Burlington Design Advisory Board

DESIGN ADVISORY BOARD Tuesday July 27, 2021 3:00 PM REMOTE MEETING

MEMORANDUM

To: The Design Advisory Board
From: Mary O'Neil, AICP, Principal Planner
RE: ZP21-0918CA/CU ZP21-213OG
38 Latham Court
Date: June 22, 2021 **July 27, 2021**

**PROPOSED
CONDITIONS
PLAN**

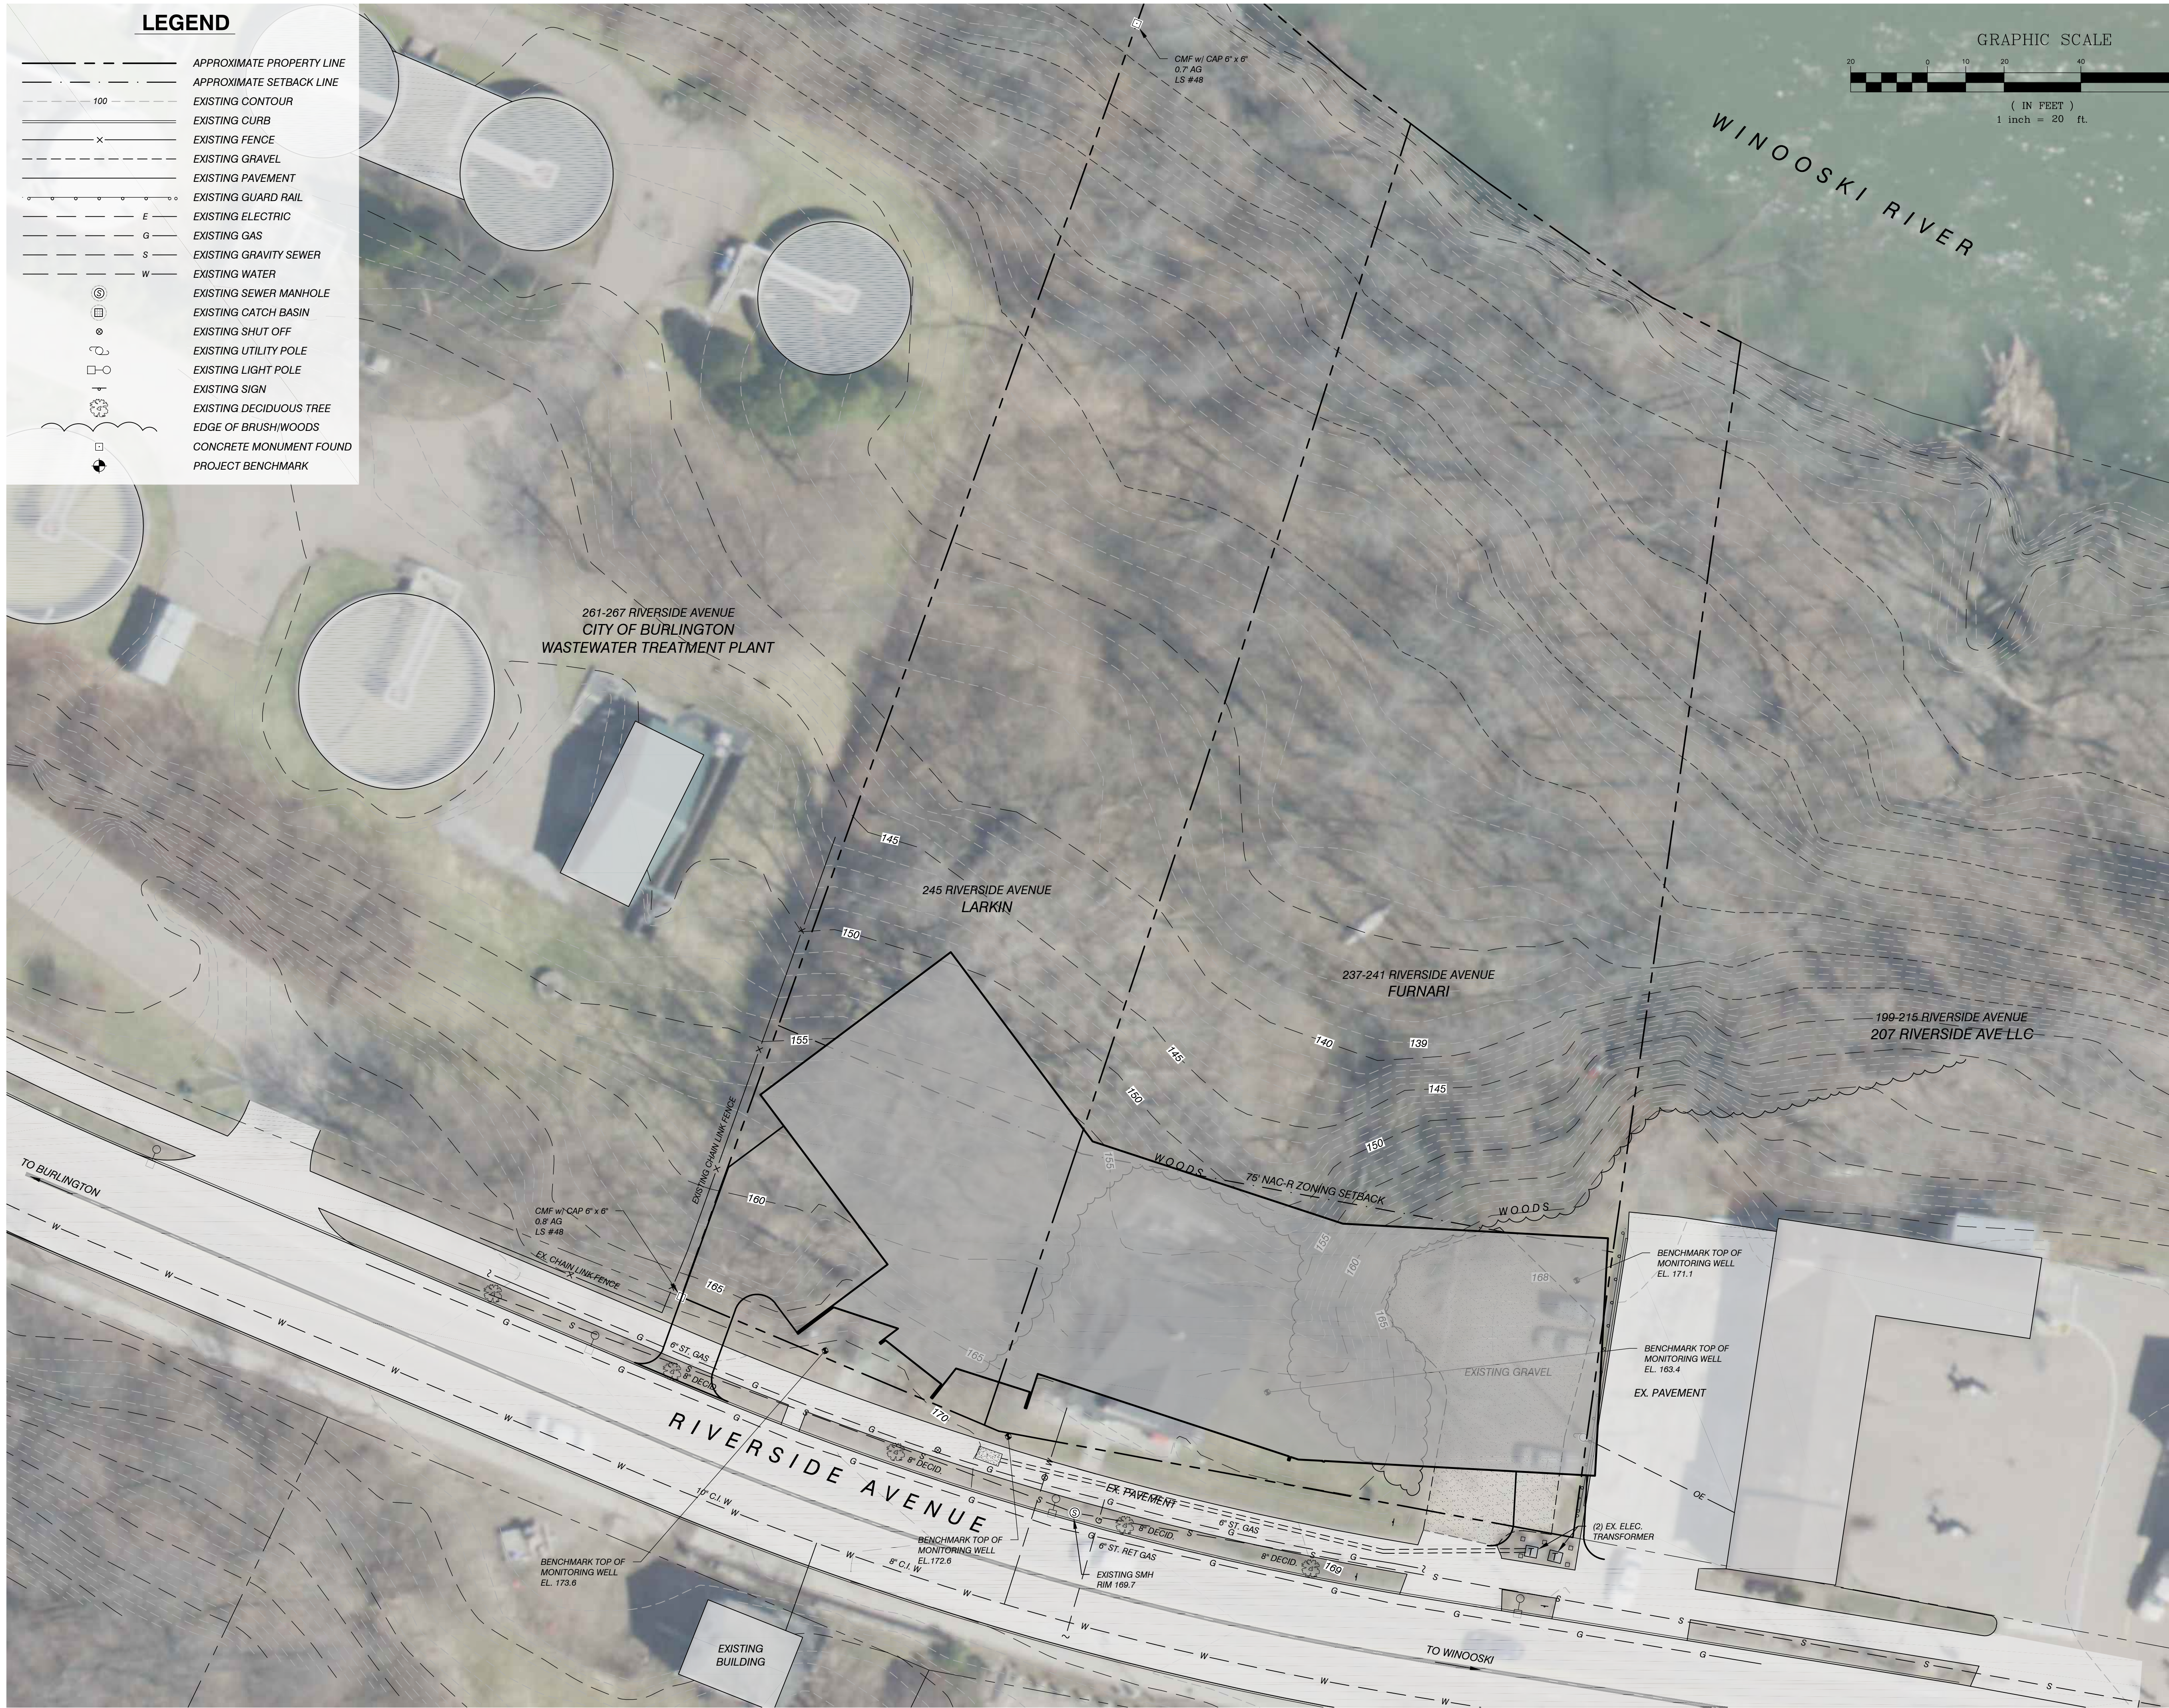
The sketch plans include an aerial photo of existing conditions, including existing topographic lines. A site plan with proposed topographic lines is not included. Based on what has been provided, it looks like the proposed building will be set atop the slope nearest Riverside Avenue. How the structure will integrate with the slope as it descends towards the river is not yet clear. The zoning permit application will need to include existing and proposed topography and a cross section depicting how the proposed building will interface with the slope of the land.

No retaining walls are depicted on the sketch plans. Presumably, given the slope of the land and the placement of the building, retaining walls will be included in the project. If so, details will be needed as to construction type and location with cross sections provided to depict adjacent grades. If in excess of 3' tall, review by the city engineer will be required.
